Planning Proposal – Independent Flooding Advice

Planning Proposal Details	
Planning Proposal	Willoughby Comprehensive Local Environmental Plan 2023
No.	PP-2021-6242
Proponent	Willoughby City Council
Local Government Area	Willoughby
Local Environmental Plan/Other Relevant EPI	<i>Willoughby Local Environmental Plan 2012</i> <i>Willoughby Development Control Plan</i>
Project summary	<p>The planning proposal aims to establish controls to deliver on the vision and objectives of Council's Local Strategic Planning Statement (LSPS, 2020), bringing together recommendations from a number of other planning studies as well. It involves updating a large number of provisions in the <i>Willoughby Local Environmental Plan 2012</i> (WLEP 2012) to create a new LEP (<i>Willoughby Local Environmental Plan 2023</i>), as well as proposed amendments to the <i>Willoughby Development Control Plan</i> (WDCP).</p> <p>The planning proposal includes rezoning land, changing development standards, particularly in the Chatswood CBD and other local centres and making other housekeeping amendments. The Chatswood CBD (red), St Leonards-Crows Nest (blue) local centres and industrial areas (purple) in the LGA where c

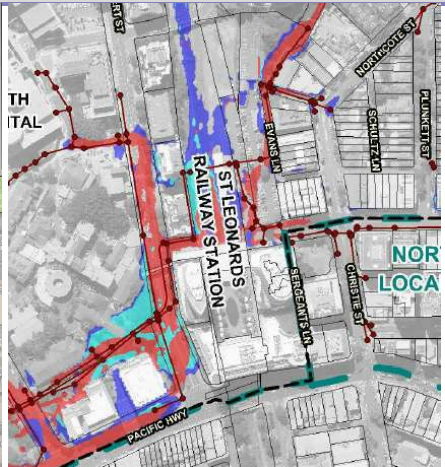
Flood Risk Assessment				
Flood Risk	Yes	No	Uncertain	Justification / Comment
				 <p>LEGEND</p> <ul style="list-style-type: none"> PMF 100 YEAR ARI 20 YEAR ARI 5 YEAR ARI HEC RAS CROSS SECTION AND RIVER STATION NUMBER <p>SCOTTS CREEK FLOOD STUDY Figure 5.2a</p> <p>INDICATIVE EXTENTS OF INUNDATION 5, 20, 100 YEAR ARI AND EXTREME FLOOD EVENTS HAMILAH STREET TO PENSHURST STREET</p> <p>R2 area affected by flooding in the PMF event in the Scotts Creek catchment (Lyll & Associates, 2008)</p>

Flood Risk Assessment				
Flood Risk	Yes	No	Uncertain	Justification / Comment
				 <p>R2 area affected by flooding in the PMF event in the Sugarloaf Creek catchment (WMA Water, 2013)</p> <p>Rhelm recommends removing materially flood-affected areas (high hazard floodway areas in the PMF event) from any proposed R2 zoning changes that would result in intensification of these areas to manage risk to life. Note that only some R2 areas flooded in the PMF event have been indicated in this advice, not all – further flood assessment is required.</p>
In a high-risk catchment (Northern Rivers, Hawkesbury-Nepean, Georges, Wilsons and Tweed rivers, Macleay, Richmond, Hunter, Clarence and Shoalhaven Rivers)	<input type="checkbox"/>	<input checked="" type="checkbox"/>	<input type="checkbox"/>	<p>The planning proposal is not within a high-risk catchment. The Willoughby LGA contains land within the following six catchments which drain to Sydney Harbour: Blue Gum Creek, Flat Rock Creek, Sailors Bay, Scotts Creek, Sugarloaf Creek and Swaines Creek catchments.</p>

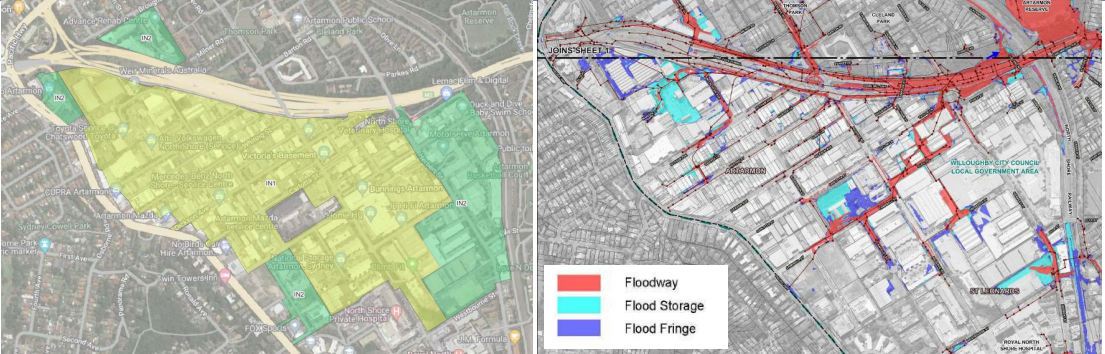
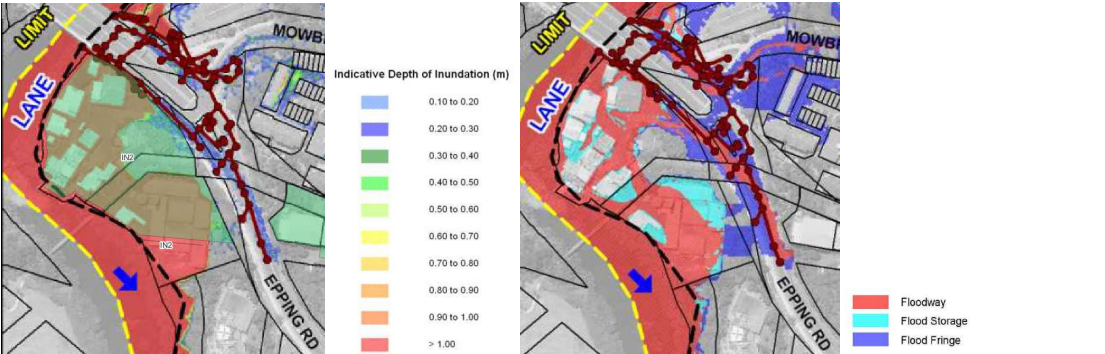
Flood Risk Assessment				
Flood Risk	Yes	No	Uncertain	Justification / Comment
				<p>In summary, the following areas in the planning proposal involve rezoning or changing of planning controls that affect land located within a floodway in the PMF event:</p> <ul style="list-style-type: none"> Chatswood CBD (has been reasonably assumed, as explained below) Local Centres – Artarmon, Penshurst Street (floodway is generally contained to roadways) and Willoughby South St Leonards-Crows Nest Industrial Land – Artarmon, East Chatswood and Lane Cove North R2 Low Density Residential zone – given the scale of the extent of this change, this was not assessed in detail in this flood advice (only preliminary assessment showing some areas are affected in the PMF). <p>Chatswood CBD</p> <p>There is no publicly available flood mapping that covers the Chatswood CBD as this is currently under revision as part of the preparation of the Scotts Creek Floodplain Risk Management Study and Plan (FRMSP, in progress as at May 2023). Therefore, there is no formal confirmation of flood extent and flood function located within the Chatswood CBD in the PMF event. However, given the presence of overland flow paths along Victoria Avenue as discussed in the 2008 Flood Study and information available to Rhelm that is currently under revision as part of the FRMSP, the west-east road alignment of Victoria Road and parallel roads were traversed by the alignment of the upper reaches of Scotts Creek which have since been piped. However, the capacity of the pipes is not sufficient to carry floodwaters up to and including the PMF and this instead flows overland through the CBD.</p> <p>It can also be reasonably assumed there is informal flood storage located within the Chatswood CBD in the PMF event as the Flood Study discusses “the potential storage of overland flows traversing eastwards along Victoria Avenue in the basement car park of Chatswood Chase”.</p> <p>Local Centres</p> <p>Artarmon: The Artarmon Local Centre contains both floodway and flood storage in the PMF event in the B2 area, based on PMF hydraulic categorisation mapping presented in the Flood Study (Lyll & Associates, 2018) as shown below. Note that PMF hydraulic categorisation mapping is not presented in the more recent FRMS&P for this catchment, which shows a greater PMF extent in this area, however the 1% AEP hydraulic categorisation mapping in the FRMS&P confirms the presence of floodway and flood storage at this site.</p>

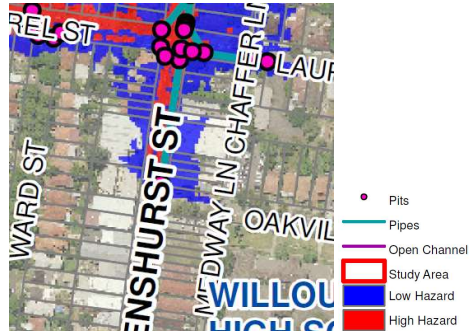
Flood Risk Assessment				
Flood Risk	Yes	No	Uncertain	Justification / Comment
				 <p>Left: Proposed zoning map; Right: PMF hydraulic categorisation from Figure 6.17 (sheet 1 of 3) (Lyll & Associates, 2018)</p> <p>Penshurst Street: In the Sugarloaf Creek catchment, WMA Water (2013) reported: "Overland flow paths, generally along roads, are classified as high hazard/floodways as a significant portion of floods is conveyed along these flow paths. There are no areas considered as flood storage in the catchment with all remaining inundated land flood classified as low hazard/flood fringe." As such, the Penshurst Street Local Centre contains floodway but not flood storage in the PMF event in the north of the B2 and B5 areas, based on PMF hydraulic hazard mapping presented in the FRMS&P (WMA Water, 2013) as shown later in this table. Areas of floodway appear wholly contained to roadways within the local centre.</p> <p>Willoughby South: The Willoughby South Local Centre contains both floodway and flood storage in the PMF event in the B2 area, particularly to the west of Willoughby Road, based on PMF hydraulic categorisation mapping presented in the Flood Study (Lyll & Associates, 2018) as shown below. Note that PMF hydraulic categorisation mapping is not presented in the more recent FRMS&P for this catchment, which shows a greater PMF extent in this area, however the 1% AEP hydraulic categorisation mapping in the FRMS&P confirms the presence of floodway and flood storage at this site.</p>

Flood Risk Assessment				
Flood Risk	Yes	No	Uncertain	Justification / Comment
				<div> </div> <p>Left: Proposed zoning map; Right: PMF hydraulic categorisation from Figure 6.17 (sheet 1 of 3) (Lyll & Associates, 2018)</p> <p>St Leonards-Crows Nest</p> <p>St Leonards-Crows Nest contains both floodway and flood storage in the PMF event in the B3 and R4 areas where changes are proposed, based on PMF hydraulic categorisation mapping presented in the Flood Study (Lyll & Associates, 2018) as shown below. Note that PMF hydraulic categorisation mapping is not presented in the more recent FRMS&P for this catchment, which shows a greater PMF extent in this area, however the 1% AEP hydraulic categorisation mapping in the FRMS&P confirms the presence of floodway and flood storage at this site.</p>

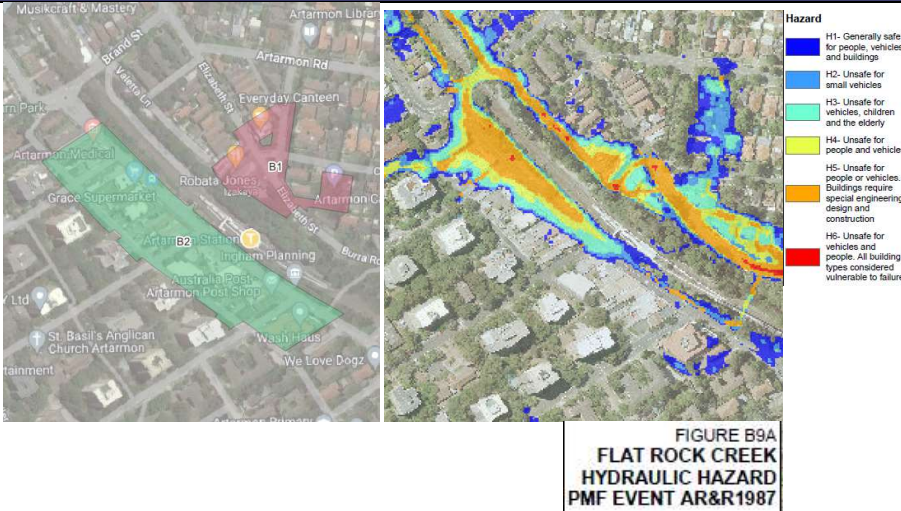
Stakeholder Consultation		
DPE BCD Comment	Proponent/Consultant Response	Rhelm Comment
<p><i>[From DPE BCD letter dated 27 May 2022:]</i></p> <p>EHG raises concern about the adequacy of the consistency assessment with Local Planning Directions 4.1 Flooding as the planning proposal states ““Upzoned” land which is identified in any flood studies will be subject to water management controls within the Willoughby DCP”.</p> <p>EHG advises that DCP controls cannot be substituted for consideration of the direction at the planning proposal stage. The planning proposal seeks to increase intensity of development and where this land is flood affected, the local planning direction must be considered. For example, Hampden Road in Artarmon is flood prone land to which the provisions of the direction would apply. EHG recommends that Council reviews the extent of flood prone land to determine where the direction is to be considered.</p>	<p><i>[From Willoughby City Council letter dated 23 February 2023:]</i></p> <p>I am writing to advise you that at its meeting of 12 December 2022, Council resolved to forward the comprehensive LEP Planning Proposal to the Department of Planning and Environment for finalisation, following certain amendments. The amendments referred to in the Council resolution are now complete.</p> <p>The Council report and resolution along with relevant documentation has been uploaded onto the Planning Portal.</p> <p>Also uploaded to the Planning Portal are two Tables explaining the written and mapping changes.</p> <p><i>[Verbal discussions – DPE also noted the following to Rhelm based on verbal discussions with Council to respond to EHG concerns:]</i></p> <ul style="list-style-type: none"> • Council is aware of the sites that are subject to overland flow and the increase in density has been taken into account in areas such as Artarmon and Willoughby South Local Centres • Flood constraints identified for specific development lots do not prohibit development of those sites under existing or proposed LEP / DCP controls • Proposed heights and FSRs are maximum controls that allow for design flexibility to respond to site specific constraints. 	<p>Rhelm supports the comments made by DPE BCD, in particular that DCP controls cannot be substituted for consideration of the direction at the planning proposal stage. Further information is required in the planning proposal to provide an assessment of flood risk across the LGA.</p>

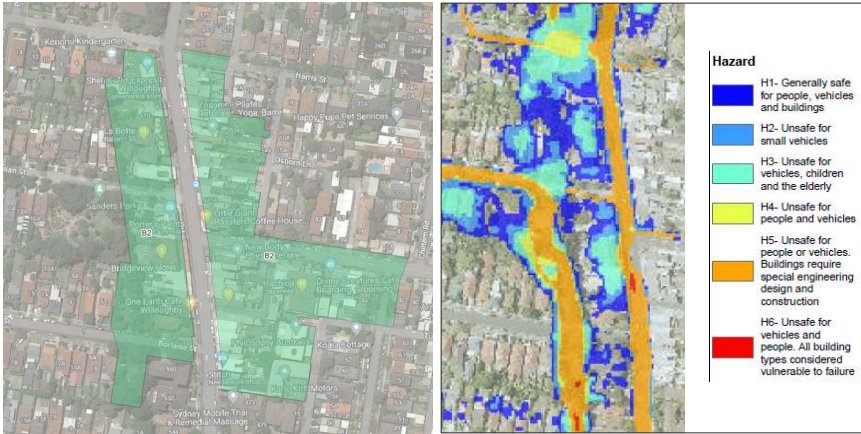
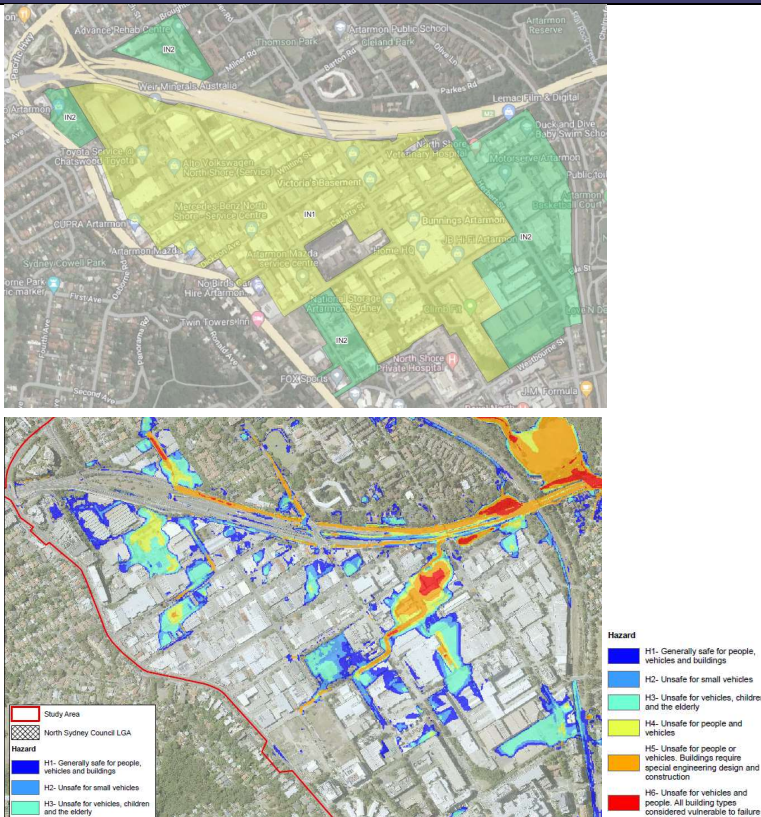
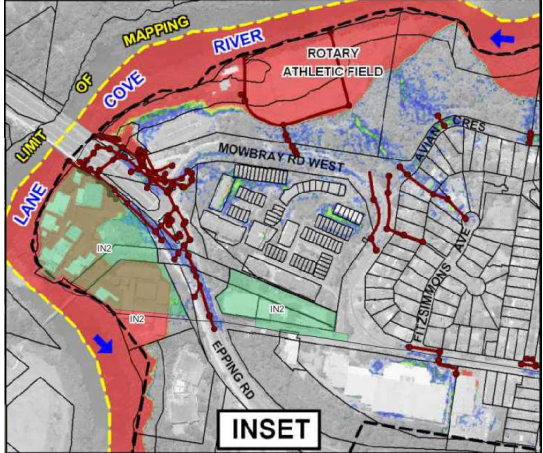
Area	Affected by PMF	Catchment	Comments	Map (showing relevant proposed zoning overlaid over PMF extent mapping from relevant flood study where available)
Penshurst Street	Yes (only northern portion of B5 and B2 to be assessed further)	Part Sugarloaf Creek and part Flat Rock Creek	<p>Small areas in the north of the B5 and B2 zones of the local centre are affected by the PMF extent in the Sugarloaf Creek catchment. Proposed changes in these flood affected areas include HOBs and FSRs changes.</p> <p>The R3 zones contained within the local centre, where FSR changes are proposed, is not affected by the PMF extent. Therefore, no further flood risk assessment required for this R3 zone.</p> <p>Small areas of B5 in the Flat Rock Creek catchment where HOBs and FSR changes are proposed (marked with orange boxes) are affected to a very minimal extent by the PMF (H1 only) and therefore no further flood risk assessment is considered necessary for this area.</p>	 <p>FIGURE B9A FLAT ROCK CREEK HYDRAULIC HAZARD PMF EVENT AR&R1987</p> <p>Left: Proposed zoning overlaid over PMF extent mapping for Sugarloaf Creek catchment; Right: PMF hydraulic hazard mapping from the Flat Rock Creek FRMS&P (WMA Water, 2020).</p>

Area	Affected by PMF	Catchment	Comments	Map (showing relevant proposed zoning overlaid over PMF extent mapping from relevant flood study where available)
Willoughby South	Yes	Flat Rock Creek	The B2 area to the west of Willoughby Road is substantially affected in the PMF. The B2 zone to the east of Willoughby Road is only affected to a very minimal degree, only by low hazard (H1-H3) flooding with the exception of two roadways indicated as H5 in the PMF. Willoughby Road itself is also indicated as H5 in the PMF, which presumably would be the primary access/evacuation route for this local centre.	 <p>Note: Proposed zoning in Flat Rock Creek catchment is not overlain but rather side by side with PMF hydraulic hazard mapping from the FRMS&P (WMA Water, 2020).</p> <p>FIGURE B9A FLAT ROCK CREEK HYDRAULIC HAZARD PMF EVENT AR&R1987</p>
